State of New Mexico
ENVIRONMENT DEPARTMENT

Hazardous Waste Bureau

February 9, 2007

SUBJECT: APPROVAL WITH MODIFICATIONS
INVESTIGATION WORK PLAN FOR
CAÑÓN DE VALLE AGGREGATE AREA
LOS ALAMOS NATIONAL LABORATORY
EPA ID # NM0890010515
HWB-LANL-06-019

Figure 3.6-1. Subaggregate 2 (MDA R) proposed investigation and sampling locations and depths

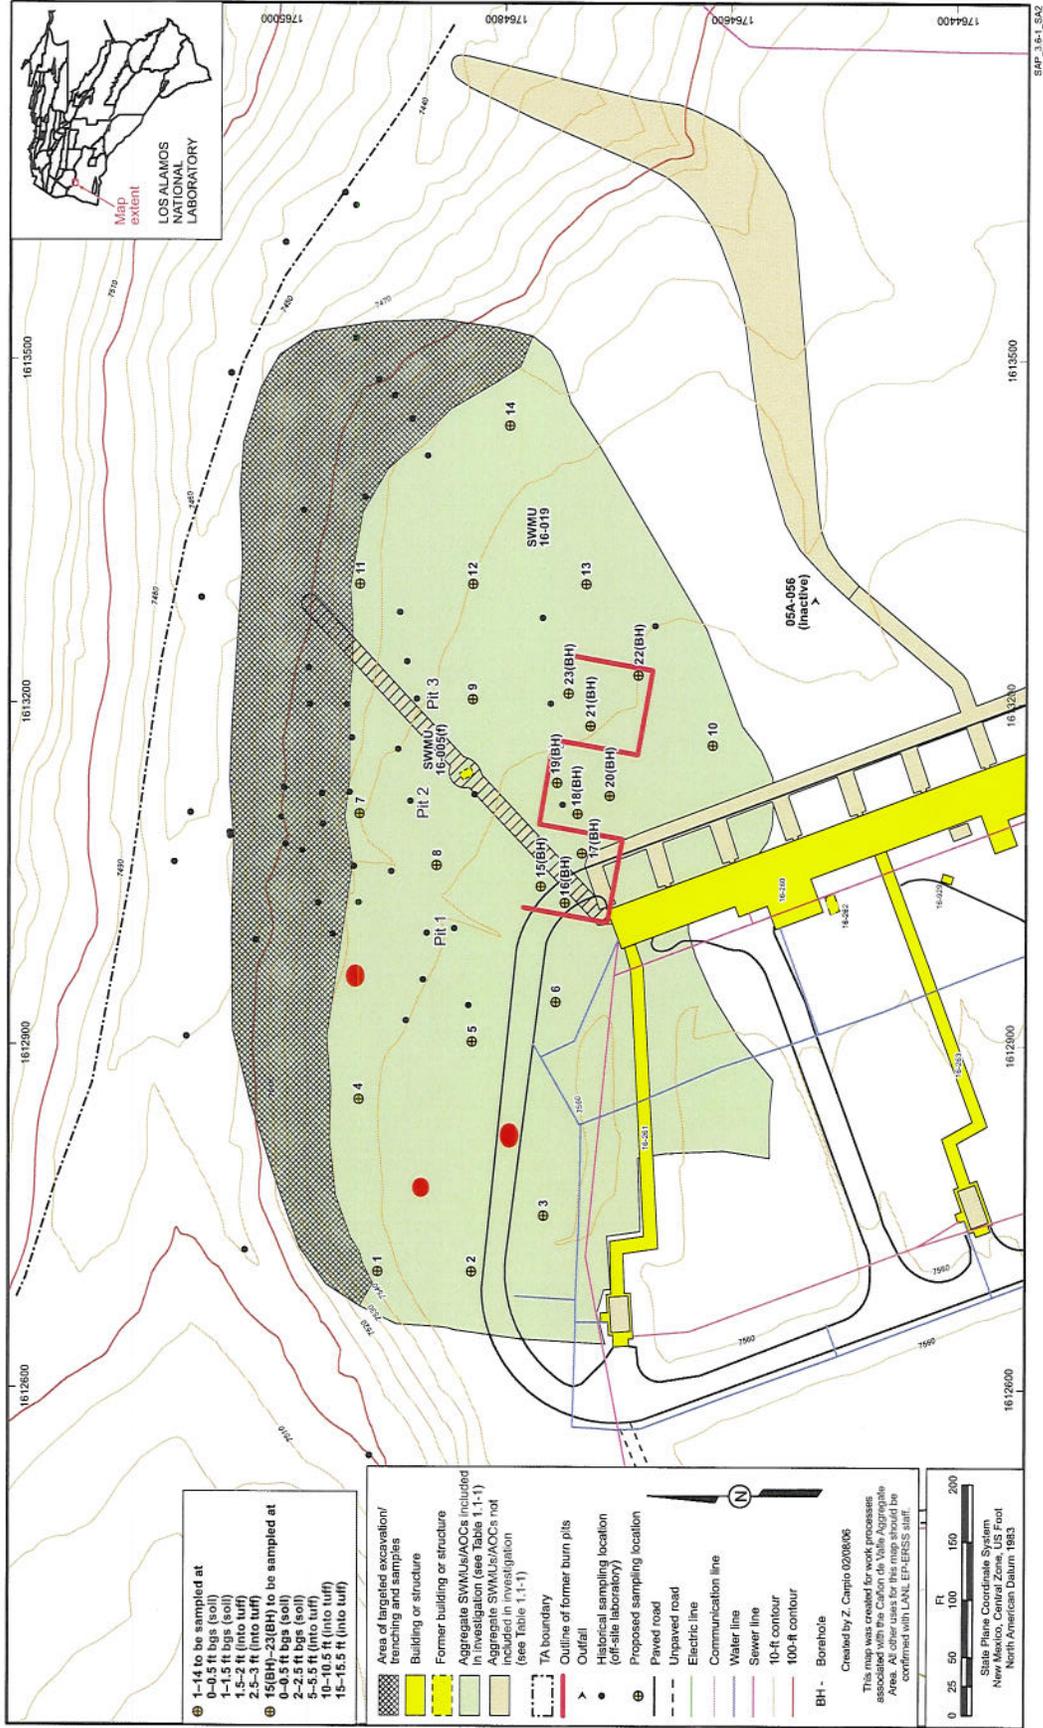
NMED comment: The Permittees have proposed a total sample depth of three feet into the tuff for borings BH1 through BH14, and 15 feet into the tuff for borings BH15 through BH23 at MDA R. The proposed maximum depths may not be sufficient to define the vertical extent of contamination at MDA R. Historical data indicate the presence of contaminants at depth (e.g., RDX, 77 mg/kg at 1.67-2.08 feet at location 16-06508; barium 4500 mg/kg at 2-3 feet at location 16-06511; barium 6800 mg/kg at 3-4 feet at location 16-06506; and lead at 1900 mg/kg at 2.5-5 feet at location 16-06533). In addition to the proposed sampling depths, the

Permittees must collect samples at depths of 7.5 and 10 feet bgs from borings BH1 through BH14.

Borings 1 through 14 are not sufficient to adequately characterize the lateral extent of the landfill. The Permittees must add another sampling location between proposed locations 4 and 7, an additional sampling location in the center of proposed locations 1, 2, 4 and 5, and an additional sampling location between proposed locations 3 and 6 in order to adequately characterize lateral extent, as shown on the attached revised map of Figure 3.6-1. Depth intervals shall be consistent with sample depths required above.

All samples must be field-screened for PCBs. A minimum of 20% of randomly selected PCB field screening results must be confirmed by laboratory analysis by EPA Method 8082. If PCBs are detected by field screening, then all samples must be submitted to an analytical laboratory for the analysis of PCBs by EPA Method 8082. See general comment #8.

Figure 7.9-3. Subaggregate 6 (WWII GMX-3 Area East) proposed sampling locations and depths

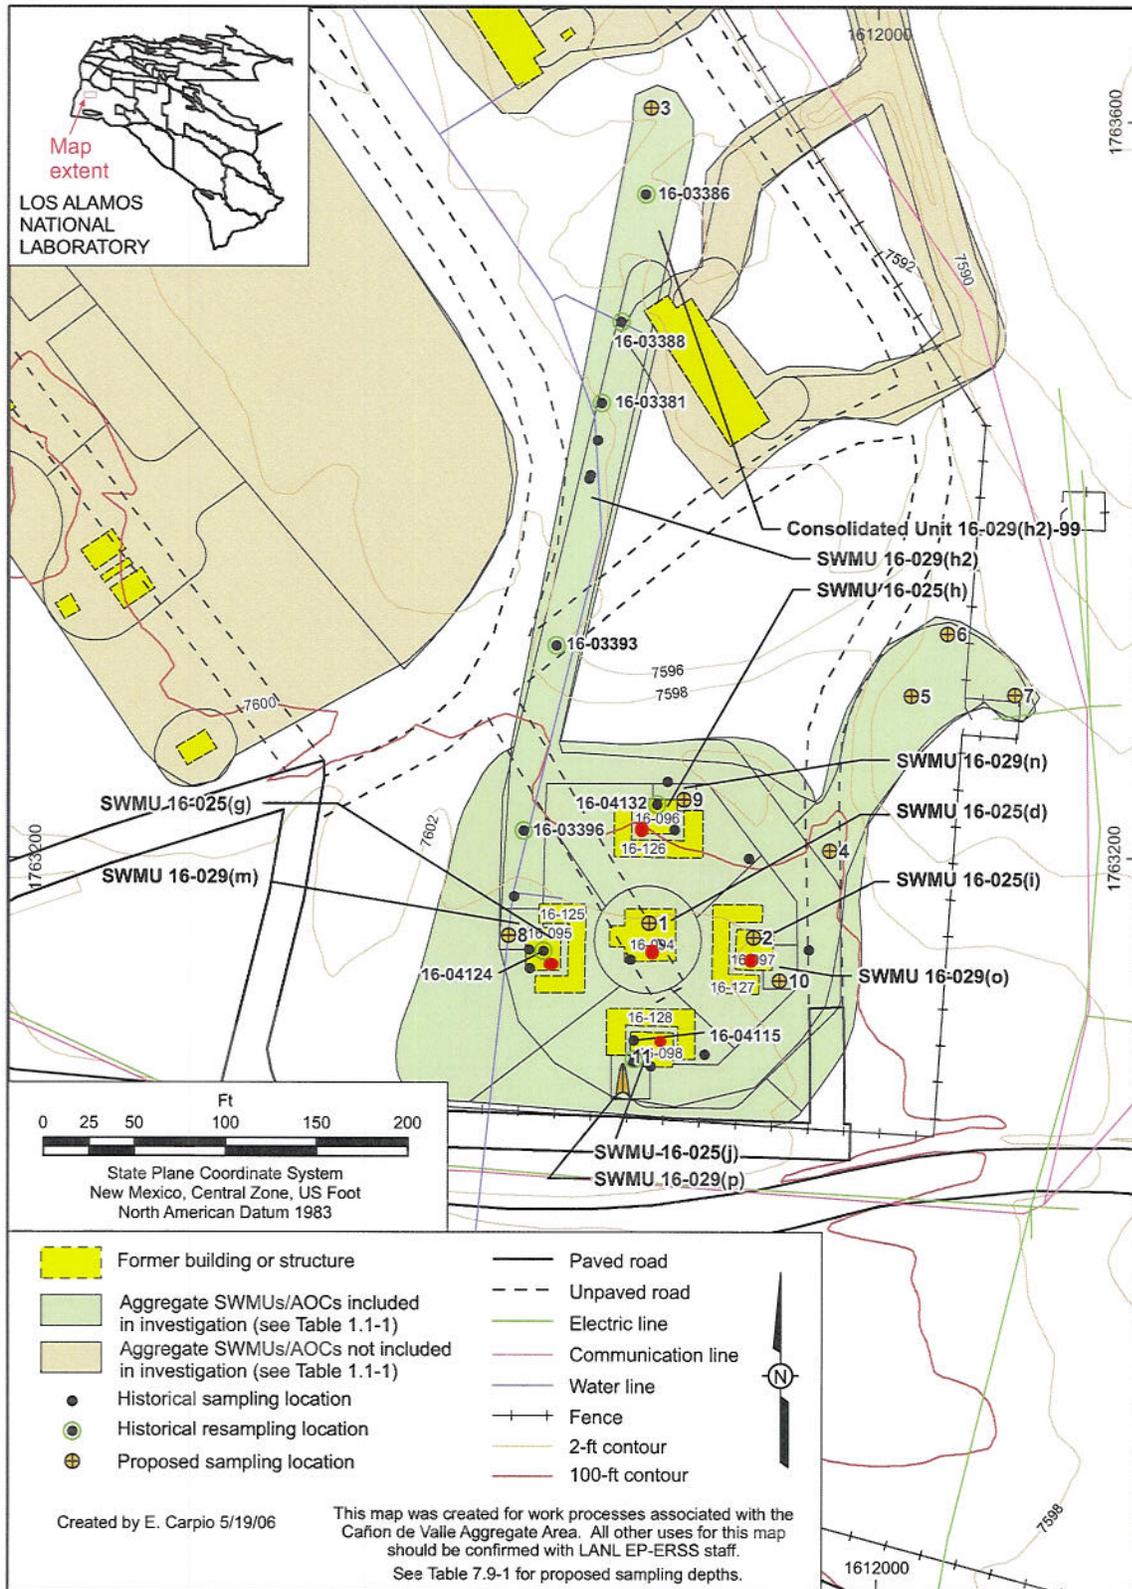
NMED comment: The proposed boring locations at SWMU 16-029(h2)-99 (shown in Figure 7.9-3, page 243) are not adequate for the purposes of characterizing nature and extent of contamination. Only one sample location is proposed at each former building location. This is in contrast to the proposed sampling at consolidated SWMU 16-029(q)-99, shown in Figure 7.9-2 (page 242), which proposes several boring locations for each site. The Permittees must collect at least one additional set of samples (i.e., one additional boring location at four depths, consistent with other proposed sampling) from each of the five former HE machining buildings to further define vertical and lateral extent as shown in the attached map of revised Figure 7.9-3.

In addition, the Permittees must clarify which former structures are indicated by 16-125, 16-126, 16-127, and 16-128. These former structure designations surround the former west, north, east, and south HE machining buildings (i.e., 16-095, 16-096, 16-097, and 16-098), but are not referenced in either the Historical Investigation Report (LANL 2006, 91697) or the Plan.

Figure 10.11-2. Subaggregate 9 (TA-15 West) proposed sampling locations and depths: MDA Z

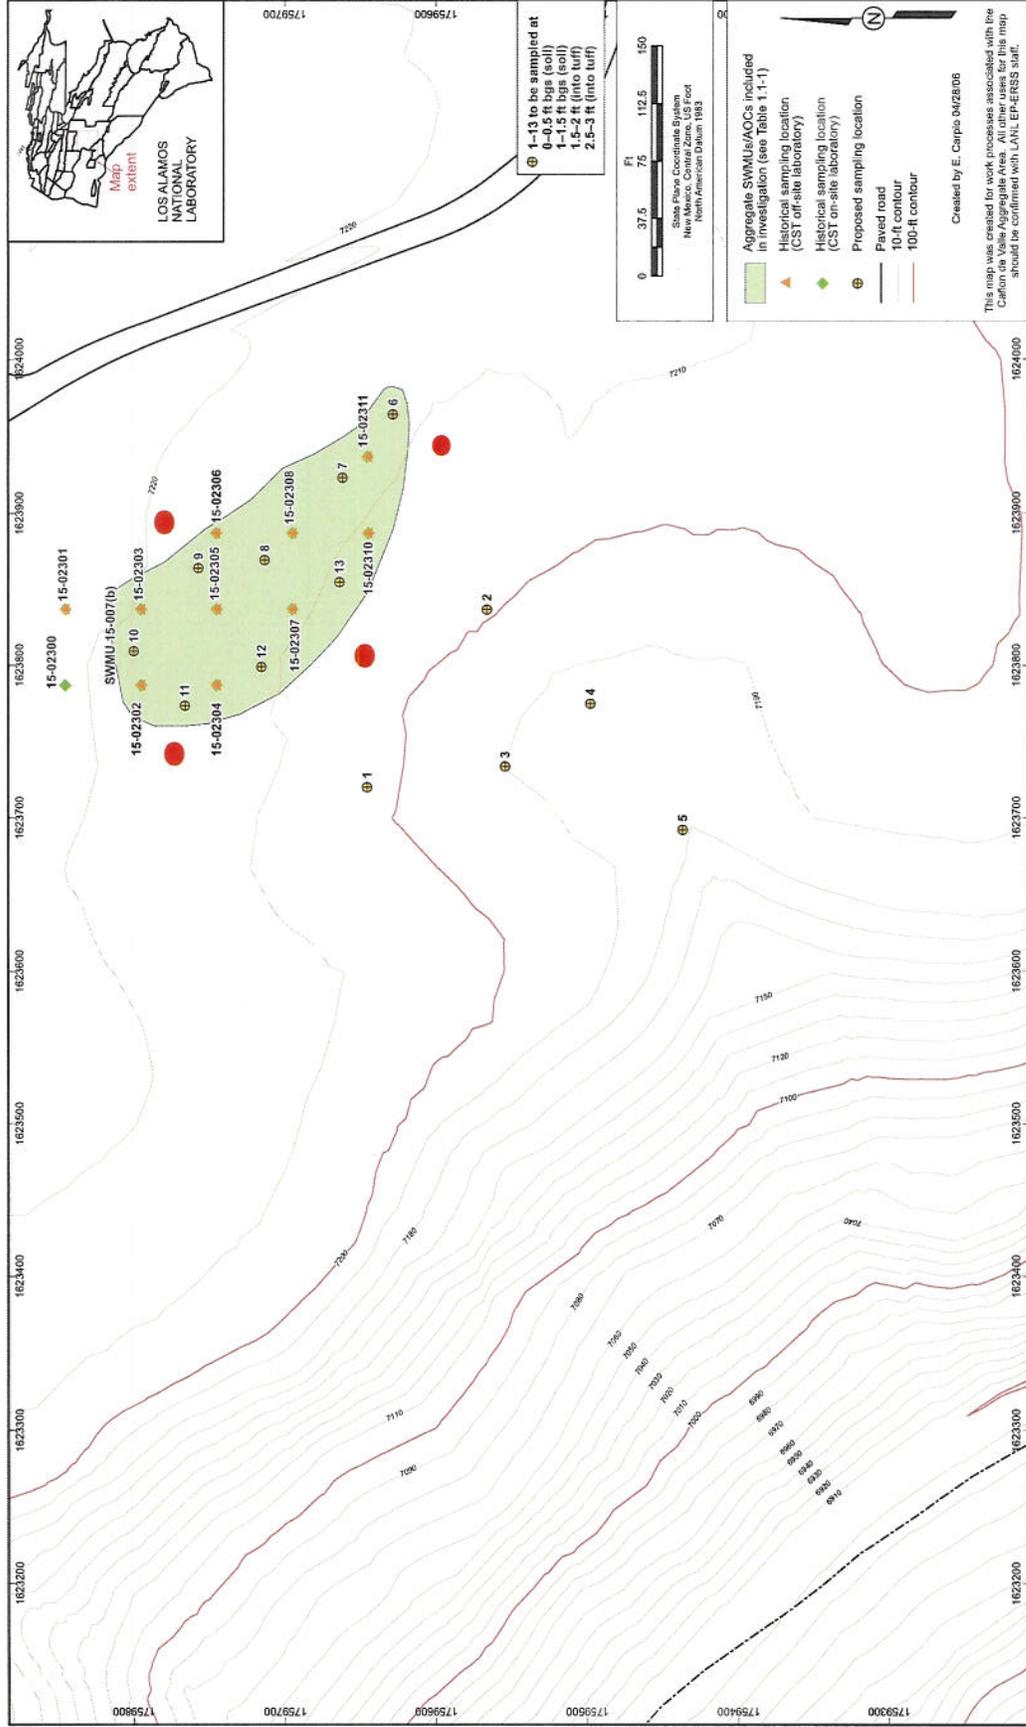
NMED comment: The proposed samples for MDA Z are insufficient to define the extent of contamination. The Permittees must collect additional samples at a minimum of 100 foot intervals in the drainage extending to the toe of the colluvium. Samples must also be collected outside the footprint of the landfill to define lateral extent. See the attached revised map of Figure 10.11-2. If contamination is detected in samples collected from 2.5-3 feet, then the Permittees must collect samples at depths greater than three feet at sampling locations 6 through 13 in accordance with the requirements outlined in the Section IX.B.2.b.i of the Consent Order. Sample locations in the drainage must be selected based on geomorphic relationships and sedimentary packages in accordance with canyon investigation procedures. Justification for the selected sampling locations must be included in the Investigation Report.
